RÜTGERS Organics Corporation

**RE: RESPONSE TO SPILL INCIDENT NOV DATED JULY 27, 2004 –
NEASE SITE, SALEM, OHIO**

**A. Responses to OEPA comments and concerns with the
information provided by ROC**

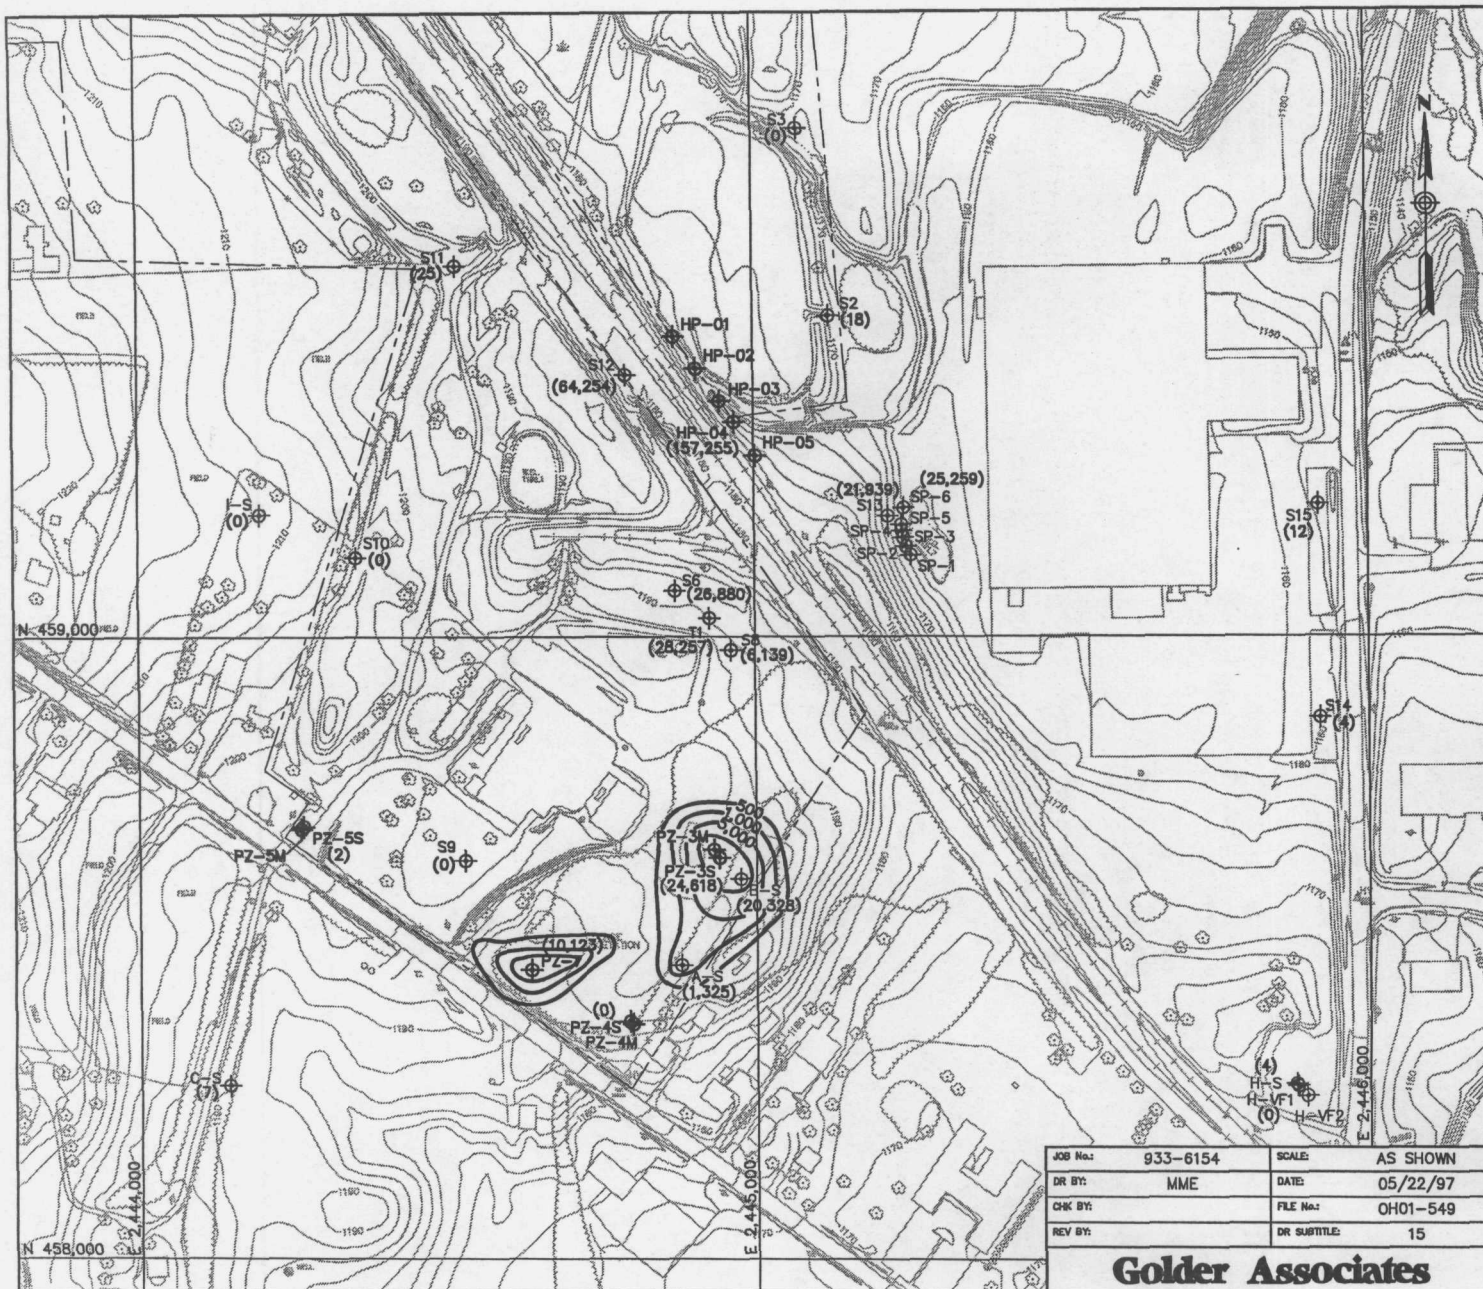
As has been previously been reported, the location of the treatment plant building is upgradient of the groundwater extraction system. Referring to the groundwater potentiometric contour map presented in Figure 2 of the Eastern Plume / DNAPL Investigation Report (see Attachment 2), the treatment plant is located on a groundwater divide, and the shallow groundwater flow in the area of the treatment plant building could flow in two different directions. As described in the Investigation Report text, the primary flow regime is toward the east/northeast where the collection system is located, and a second, less significant, regime is towards the south/southeast. The transition between the two flow directions is near the treatment plant building.

FIGURE 11

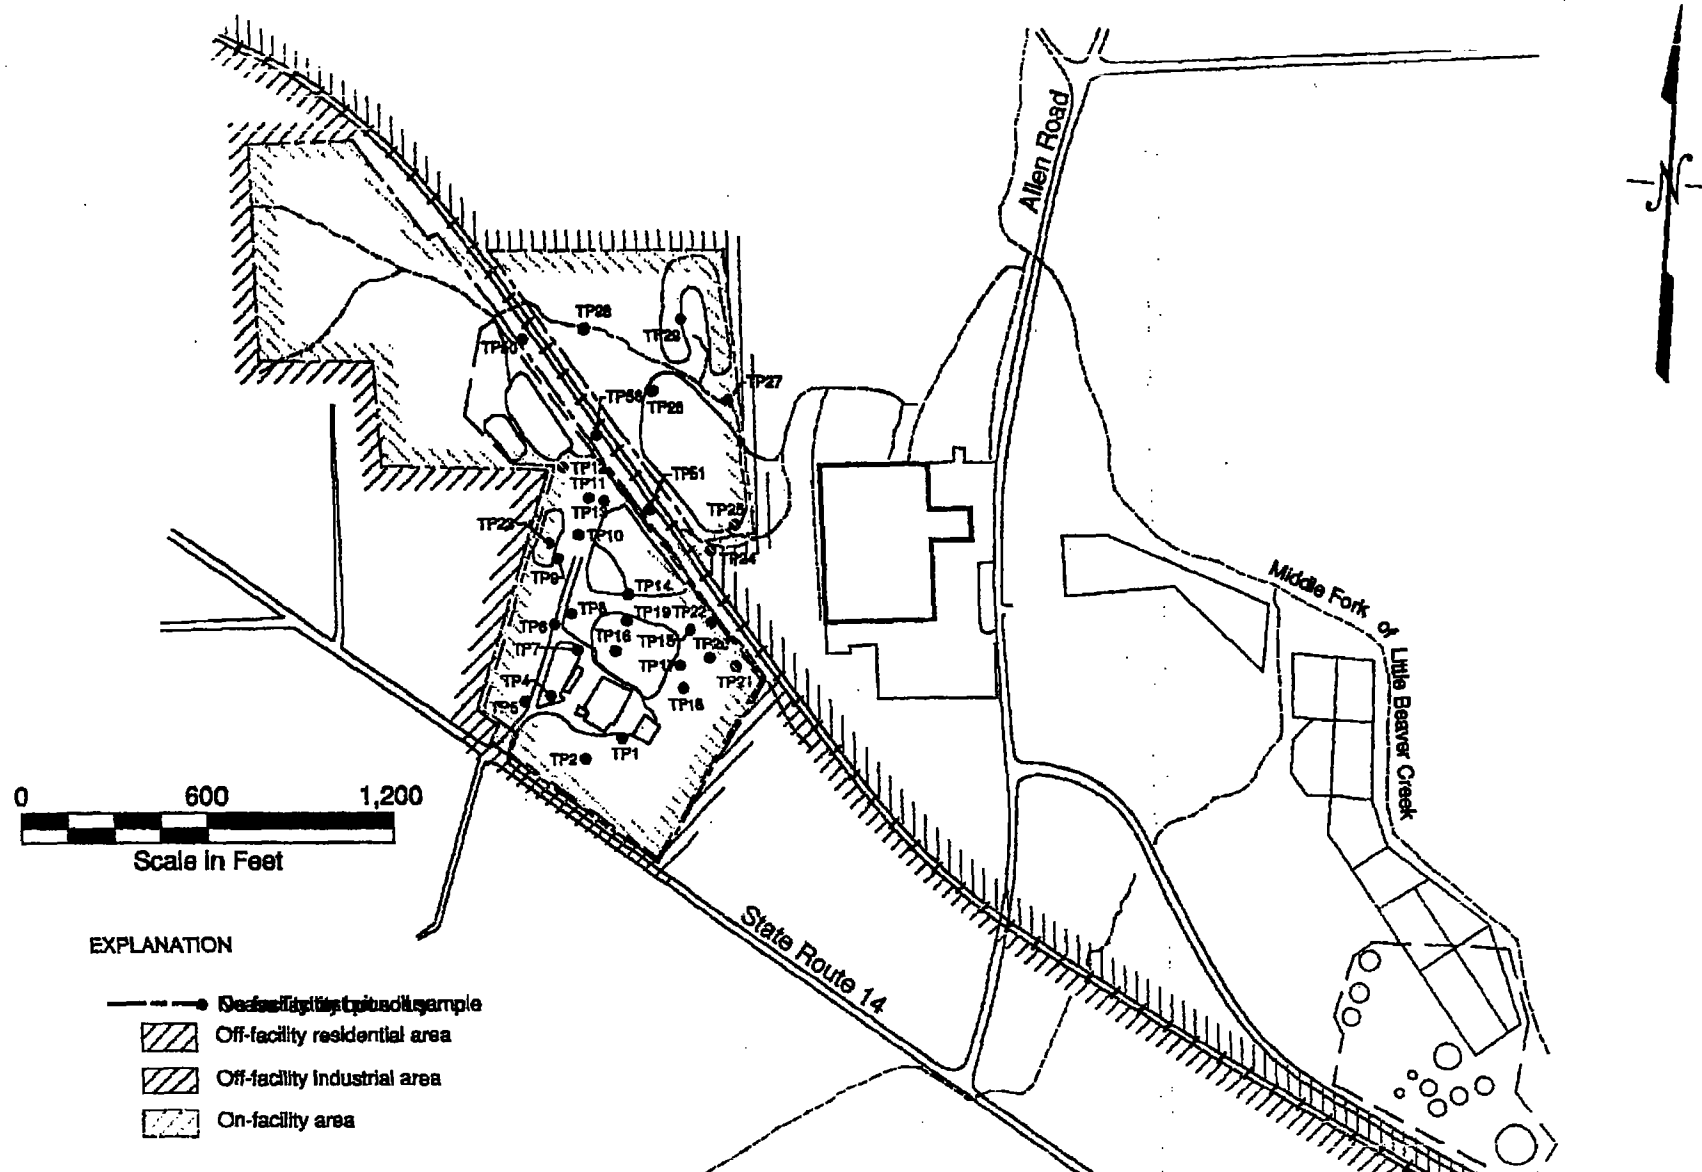
The Eastern Plume / DNAPL Investigation Report also identified existing VOC and SVOC impacts to shallow groundwater to the south and southeast of the treatment plant building, as showing in Figure 11 (see Attachment 3). The contaminants identified in the groundwater to east/northeast and south/southeast of the treatment plant are chlorinated

organics nearly identical to those detected in the analysis of spilled influent. Remediation of both areas of the groundwater is already being addressed as part of the on-going Feasibility Study (FS) for the Site.
